**SUBDIVISION REVIEW SHEET****CASE NO.:** C8-2020-0021.0A**COMMISSION DATE:** November 2, 2021**SUBDIVISION NAME:** Fort Branch Subdivision**ADDRESS:** 5016 E. Martin Luther King Jr. Blvd.**APPLICANT:** East 13<sup>th</sup> Street LLC (Robert Penta)**AGENT:** Jerome Perales (Perales Land Development LLC)**ZONING:** SF-3-NP (single family residence)**NEIGHBORHOOD PLAN:** MLK-183**AREA:** 2.9 acre (30,642 sf)**LOTS:** 8**COUNTY:** Travis**DISTRICT:** 1**WATERSHED:** Fort Branch**JURISDICTION:** Full Purpose**VARIANCES:** none**DEPARTMENT COMMENTS:**

Staff recommends disapproval of the plat for the reasons listed in the comment report dated October 28, 2021, and attached as Exhibit C.

CITY OF AUSTIN –DEVELOPMENT SERVICES DEPARTMENT  
SUBDIVISION APPLICATION – MASTER COMMENT REPORT

PROJECT NAME: Fort Branch Creek Subdivision  
 LOCATION: 5016 E MARTIN LUTHER KING JR BLVD

EXHIBIT B

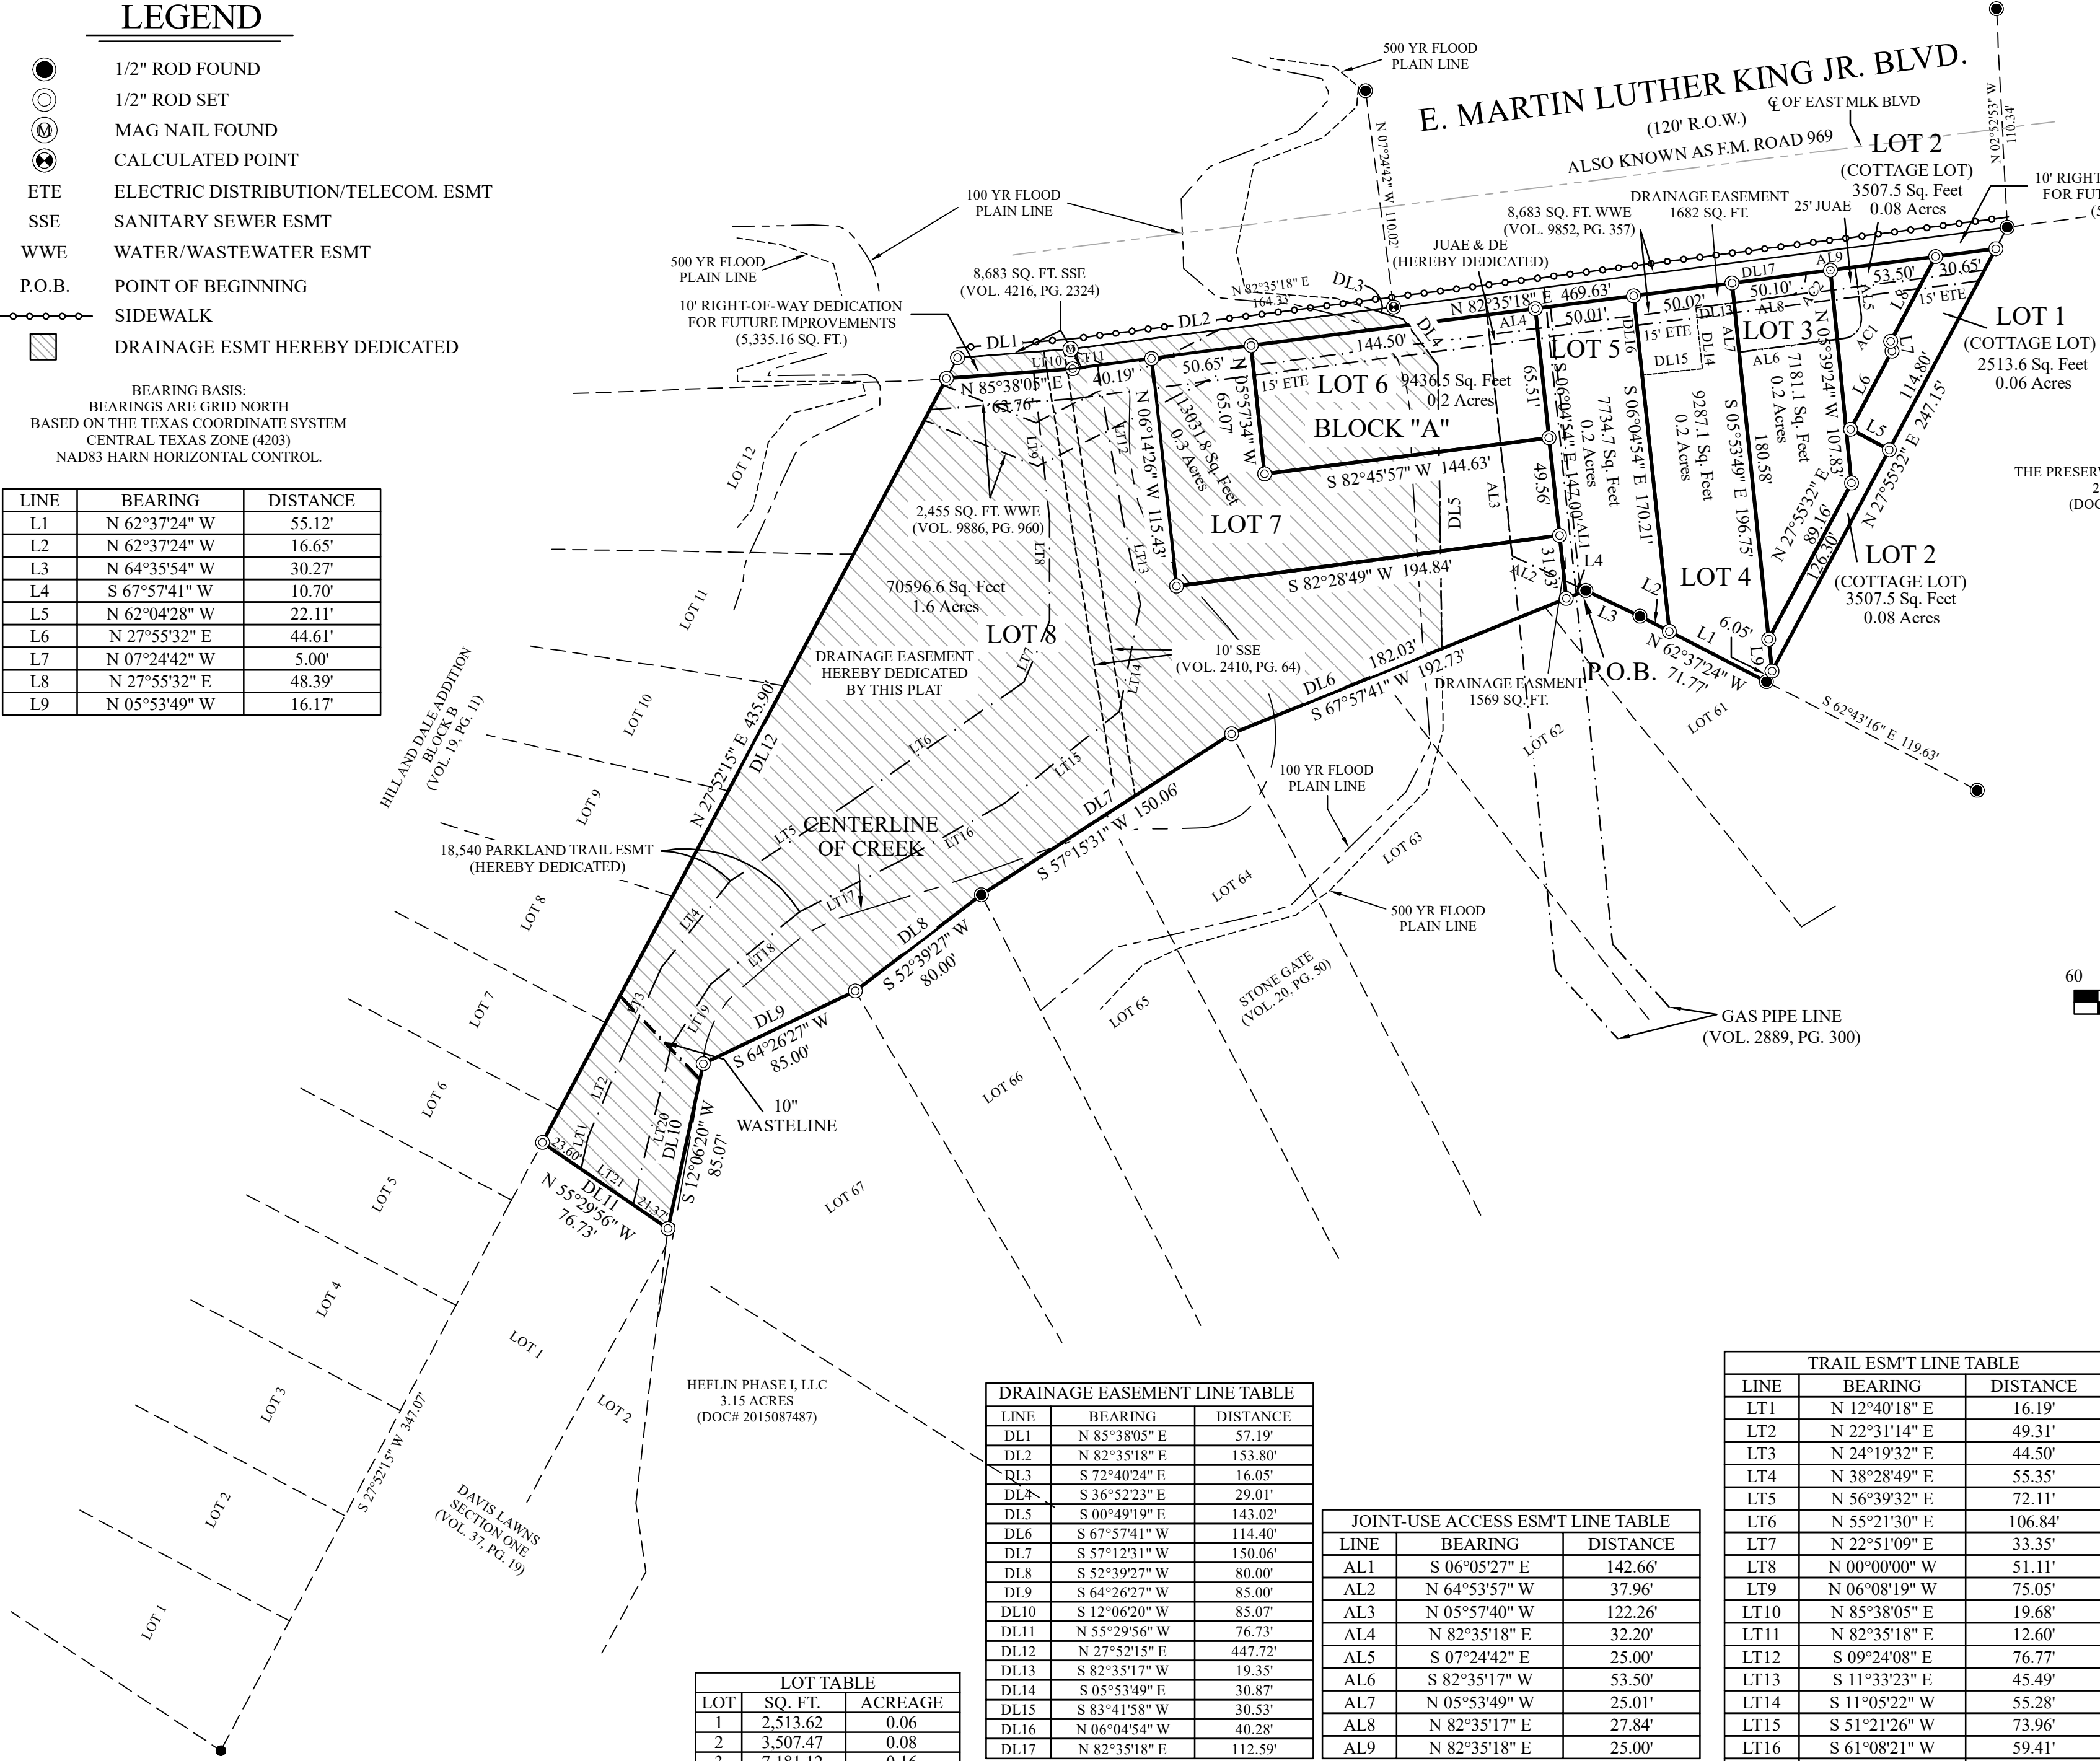
Update 1: Clarify what the hashed area on Lots 6, 7 & 8 is annotating, as shown the hashed area appears to be labeling a Parkland and Drainage Easements. Label easements accordingly and any lots that will be dedicated for Parkland.

Clearly annotate the Joint Use Access Easement on the lots.

Clarify what the 10 inch pipeline shown on the south portion of Lot 8 is for and label accordingly.

**Update 2:** Clearly delineate the access and drainage easement(s) along the front property line. Show the boundaries of the easement(s) similar to the 8,683 sq. ft. WWE, the WWE has arrows demonstrating the north and south boundaries. Please also show easements with dashed lines, the easement on Lots 2 and 3 should be shown accordingly.

**Update 2:** Applicant provided acknowledgement that the pipeline is no longer in use. Remove the shown pipeline from the plat.

**Update 2:** Annotate on the plat that Lot 6 will have cottage use.  
Include a note on the plat that list the lots that will have cottage use.

- SR 7. Clarify if Lot 2 extends to East M.L.K between Lot 1 and Lot 3. If this is correct show a callout of the area between Lot 1 and Lot 3 showing that Lot 2 is part of the triangular area along the road to show frontage for the lot. Lots not having frontage to an existing roads require a commission approved variance to finalize a plat. L.D.C [25-4-171](#)  
Update 1: Provide a callout of the area in Lot 2 along lot lines L5, L6 and the east lot line of Lot 3. The callout is needed to demonstrate that the triangular area and the strip of Lot 2 are connected.

**Update 2:** As demonstrated on the plat, the area or strip connecting the north and south portion of Lot 2 cannot be deciphered. Provide a callout of the area to show the distance between the lot.
